Design Advisory Board

Tuesday, July 14, 2026, 3:00 PM

To: The Design Advisory Board
From: Mary O'Neil, AICP, Principal Planner
RE: ZP-26-28
Location: 45 Howard Street
Date: July 14, 2026

To: The Design Advisory Board
From: Mary O'Neil, AICP, Principal Planner
RE: ZP-26-216
Location: 124-126 North Avenue
Date: July 14, 2026

E2 EAST ELEVATION
3/16 in = 1 ft

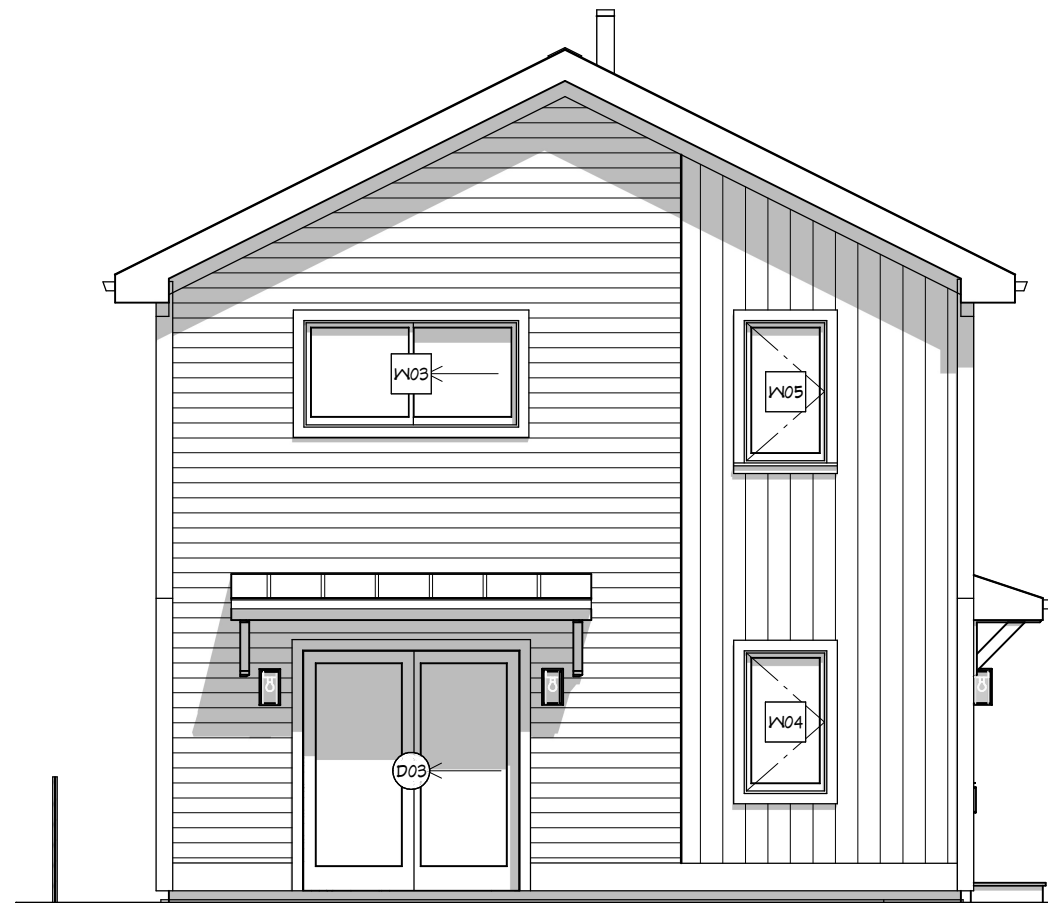
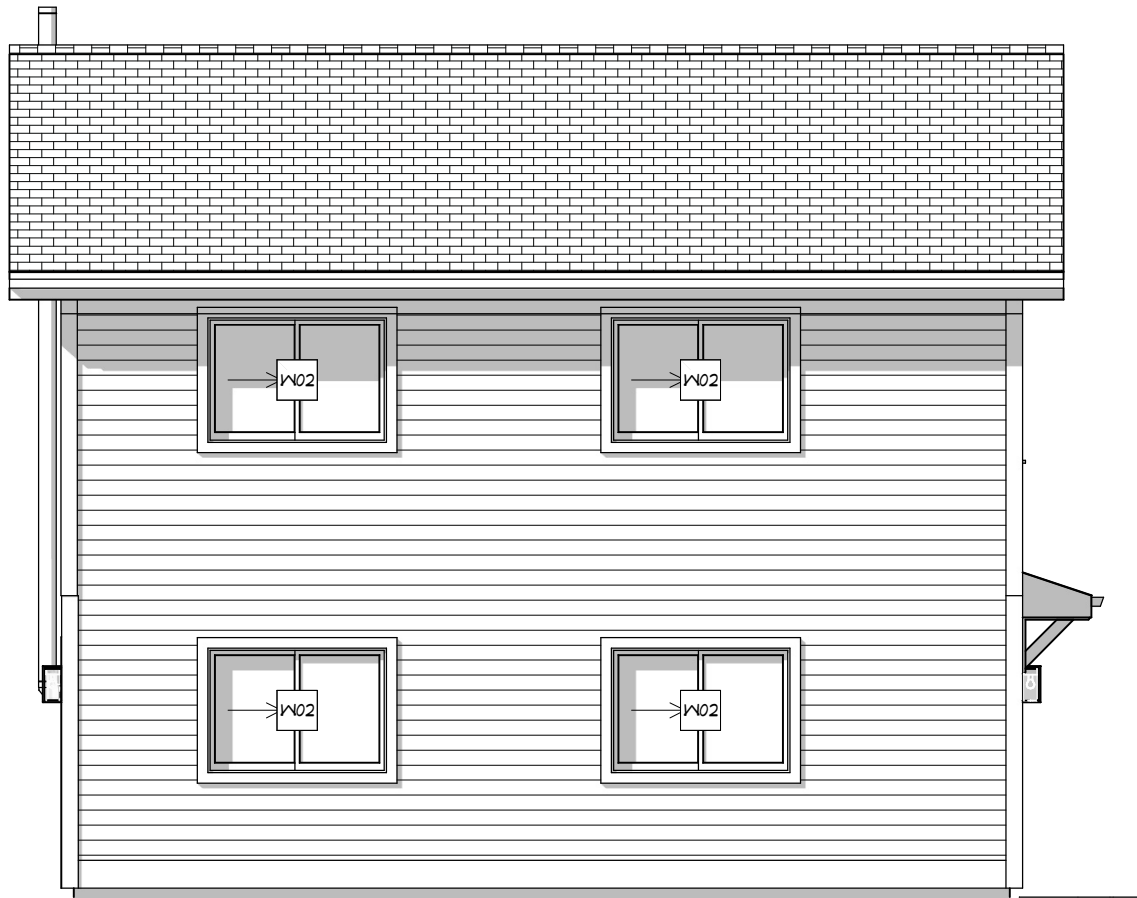
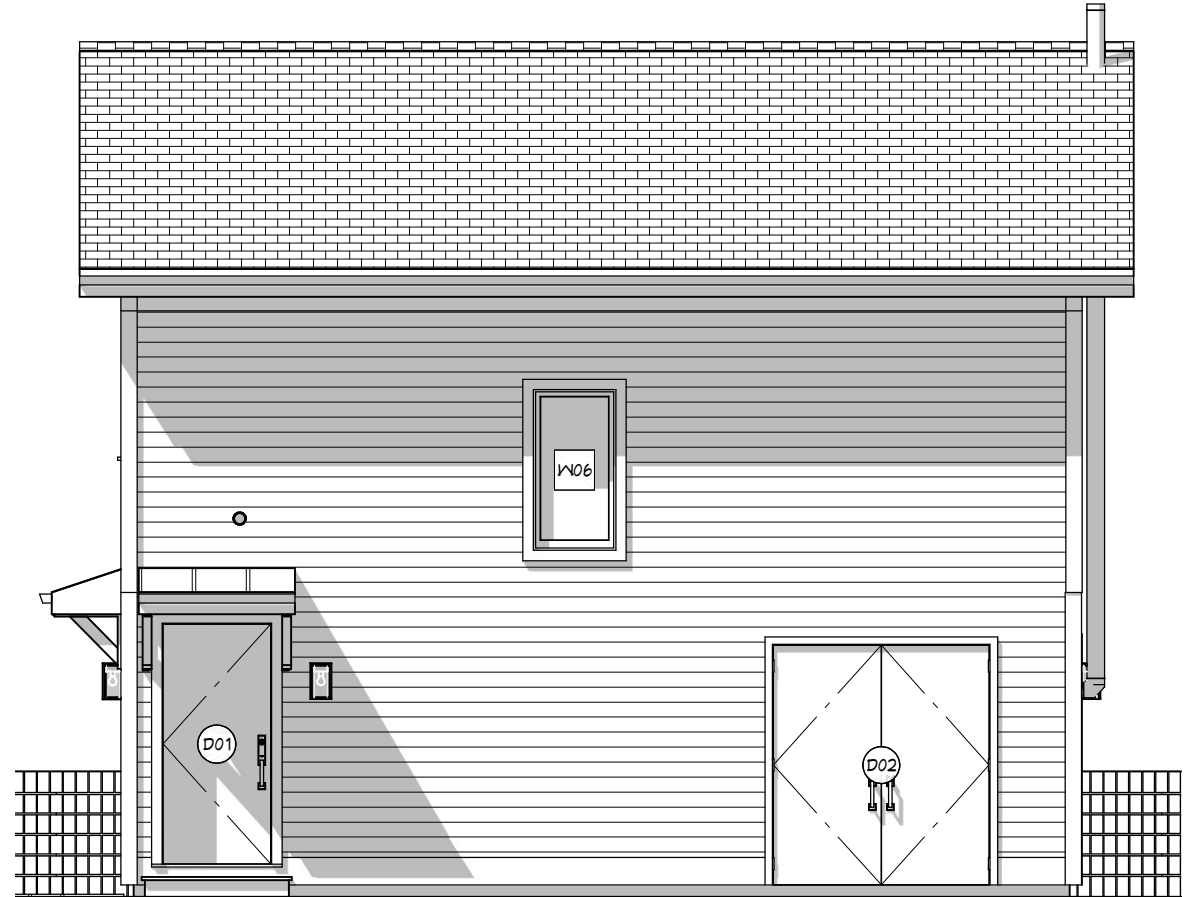
Floor plans define installation of a wood stove, but a second floor airhandler. A compressor is illustrated on Sheet 4, west elevation; and the Sheet 5, floor plan. The compressor should be added to the overall site plan as well.
